### REGULAR OPEN MEETING OF THIRD LAGUNA WOODS MUTUAL ARCHITECTURAL AND CONTROL STANDARDS COMMITTEE

#### Monday, March 28, 2022: 9:30AM - 11:30AM HYBRID VIRTUAL/IN-PERSON MEETING

SUBJECT: Variance Request: Ms. Karen Felstein of 3456-A Bahia Blanca West

SUBJECT: Variance Request: Mr. James Cook of 2173-A Via Mariposa East

DATE: 1/17/22 DRAWN BY: J.C. SITE PLAN P-01

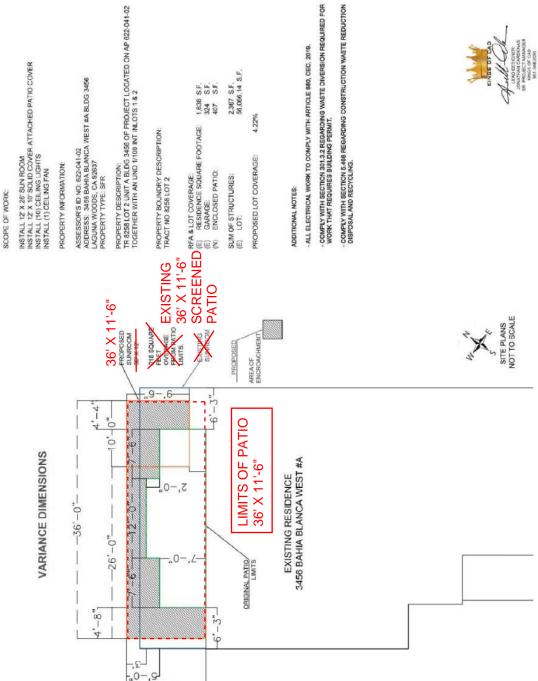
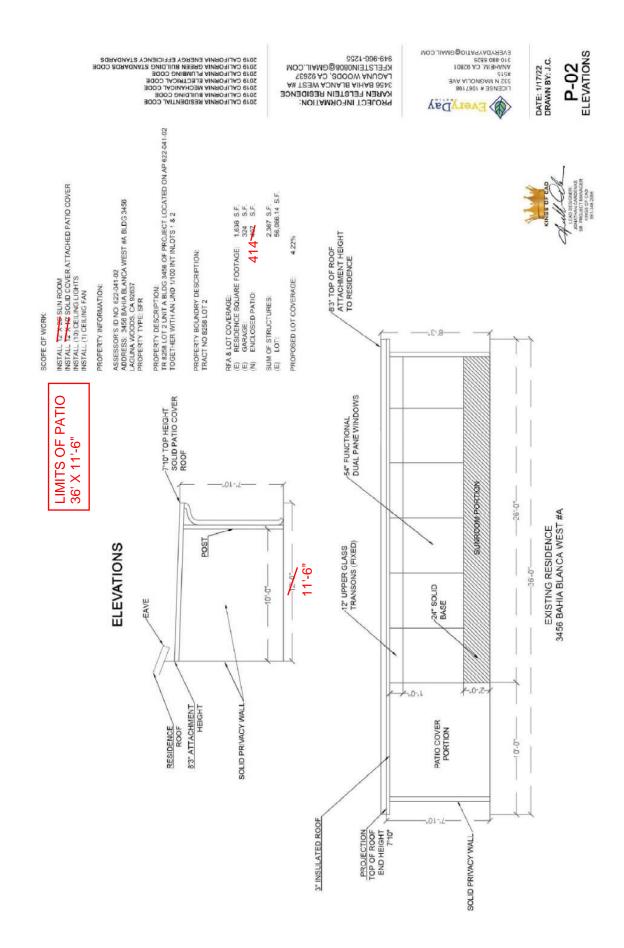
Ms. Karen Felstein is proposing to replace her existing previously approved covered patio with perimeter wall with a new 26' x 12' sunroom and 10' x 12' patio cover.

The existing covered patio currently extends beyond the original limits of the Exclusive-Use Common Area patio. The Mutual Consent from 1989 approved a low wall installation and patio cover to encompass an area of 36' x 11'6". Additionally, the sides were allowed glass windscreens in 2001 via Mutual Consent (Appendix B). Between the time of issuing Mutual Consents and the present, additional insect screen panels have been added. There is no record of consent for alteration screen panels.

Due to the unpermitted alteration and current Common Area Use Policy, Staff issued a preliminary denial letter, requiring any new construction to be limited to the original Exclusive-Use Common Area patio limits.

Upon further Committee deliberation, Staff revisited the request and determined that this could be considered a like-for-like replacement of the existing covered patio area. The submitted plans extend beyond the previously approved Common Area as part of the project (patio length request for 12 feet, while existing patio is 11 feet 6 inches) which is direct violation of existing Common Area policy, therefore, in order for the patio enclosure to be considered like-for-like, it will be required to be contained within the limits, 36' x 11'6", as defined by the Mutual Consent from 2001. Revised drawings will be required to comply with these limits.

Structural drawings and calculations will be required for the patio enclosure.

- A.1. Dimensions approved for patio enclosure must be contained in its entirety within the originally approved patio dimensions of 36' x 11'6".
- A.2. This approval does not change the number of bedrooms or the original maximum occupants permitted in the Unit.

- A.3. This approval allows temporary permission for non-conforming patio slabs, patio wall, and patio enclosure per the attached approved drawings in common area.

- B.1. Patio Slabs shall conform to Third Mutual Standard 21.
- B.2. Patio Walls shall conform to Third Mutual Standard 6.

B.3. Prior to the issuance of a Mutual Consent for Alterations, a sample of the prefabricated enclosure to be installed shall be provided to Manor Alterations for review and approval.

#### ATTACHMENT 1 SCOPE OF WORK

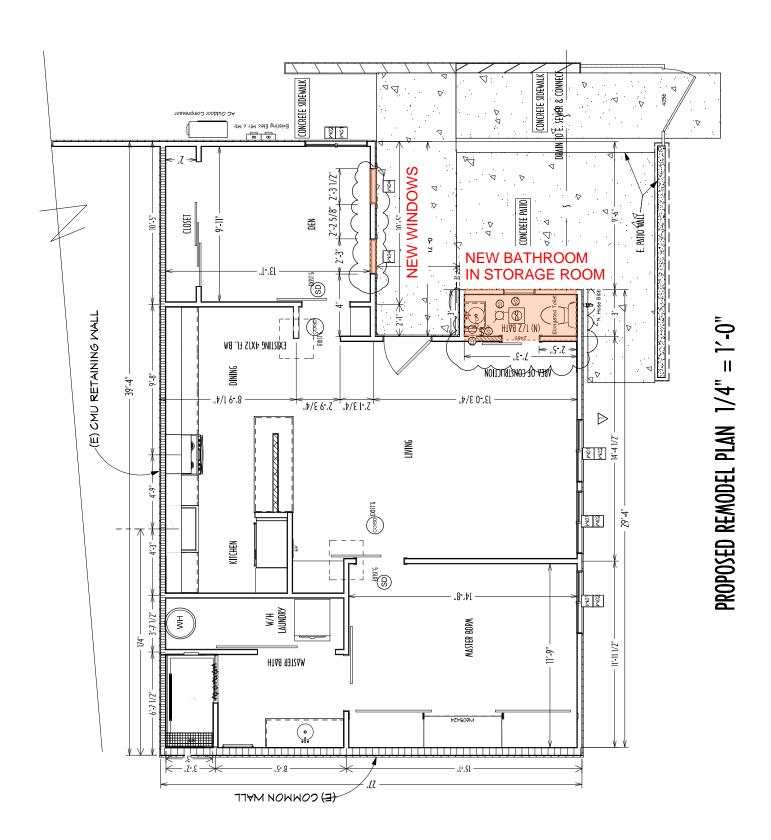
Mr. James Cook is proposing to add a bathroom in the space currently occupied by the storage closet.

The existing storage closet is an integral portion of the exterior walls of the unit. The full height walls have an exterior stucco finish. However, the storage closet is located on Exclusive-Use Common Area per the original tract map (Appendix B), and is therefore not a part of the original manor square footage.

The doors of the storage closet will be removed and the stucco wall will be infilled and repaired to match the existing stucco. The wall between the storage closet and the living room will be opened up to provide a door into the new bathroom. The new bathroom will add approximately 21 square feet to the unit. There will be a window for natural light and ventilation facing into the patio. The walls facing the patio shall be repainted to match existing to provide a consistent finish appearance.

All walls to be demolished shall be verified to be non-bearing prior to demolition.

The area of the existing storage closet to be occupied by the addition shall be demolished and replaced with a new slab, footings and moisture barrier per current building code, to match the existing interior floor slab elevation. An overpour will not be allowed. Additionally, no alterations shall be allowed beyond the original construction exclusive-use common area limitations per original tract map as shown in Appendix B.

- A.1. This approval does not change the number of bedrooms or the original maximum occupants permitted in the Unit.
- A.2. The Member shall provide plans, specifications, and calculations from a duly licensed structural engineer to conform to the Building Code for all foundation, framing, and beam additions for the work of this variance.
- A.3. A City of Laguna Woods Building Permit will be required and provided to Manor Alterations to verify all code requirements for new or modified structural components, and shoring have been satisfied.

- B.1. Any piping in bathrooms with adjacent units shall be insulated for sound reduction, including penetrations through framing.
- B.2. All walls to be demolished shall be verified to be non-bearing prior to demolition.
- B.3. The area of the existing patio/storage slab to be occupied by the addition shall be demolished and replaced with a new slab, footings and moisture barrier per current building code, to match the existing interior floor slab elevation. An overpour will not be allowed.

B.4. No alterations shall be allowed beyond the original construction exclusive-use common area limitations per original tract map as shown in Appendix B.
